Access Compliance Report

Public Rights-of-Way

Intersection ID: 30144	Main Street: CAGNEY_ST	Cross Street: RUMPLE_RD	Location:	N
ADA ID: 16EC160A177B	Ramp Type: Perp	Initial Pass/Fail: Fail	Overall Compliance: No	Severity Score: 10

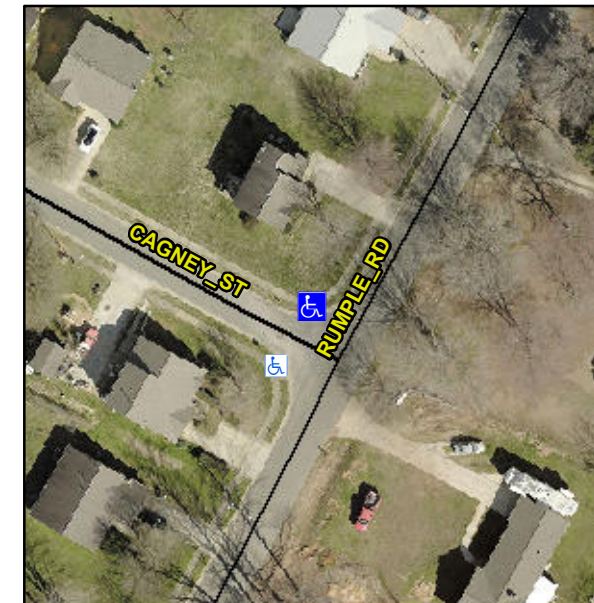
Not Found, R304.5.1, R304.5.3

Compliance	Description	Data	Compliance	Description	Data
N/A	Ramp Length (in)	49.0	Yes	Ramp Slope (%)	5.2
No	Ramp Width (in)	44.0	No	Ramp XSlope (%)	2.6
N/A	Flare Type LT	N/A	N/A	Flare Type RT	N/A
N/A	Flare Slope LT (%)	N/A	N/A	Flare Slope RT (%)	N/A
N/A	Flare Traversable LT?	N/A	N/A	Flare Traversable RT?	N/A
N/A	Landing Length (in)	N/A	N/A	DWS Provided?	N/A
N/A	Landing Width (in)	N/A	N/A	DWS Contrast?	N/A
N/A	Landing Slope (%)	N/A	N/A	DWS Length (in)	N/A
N/A	Landing X Slope (%)	N/A	N/A	DWS Full Width?	N/A
N/A	Landing Curb? (Y/N)	N/A	N/A	DWS Offset (in)	N/A
N/A	Shared Landing?	N/A			
N/A	Gutter Ponding?	N/A	N/A	Gutter Slope (%)	N/A
N/A	Gutter Lip Ht (in)	N/A	N/A	Gutter X Slope (%)	N/A
N/A	Painted X Walk1?	No	N/A	Painted X Walk2?	N/A
	X Walk 1 Direction	To SW		X Walk 2 Direction	N/A
N/A	X Walk 1 Width (in)	N/A	N/A	X Walk 2 Width (in)	N/A
	X Walk 1 Slope (%)	0.4		X Walk 2 Slope (%)	N/A
	X Walk 1 X Slope (%)	0.6		X Walk 2 X Slope (%)	N/A

Remove & Replace Entire Ramp.
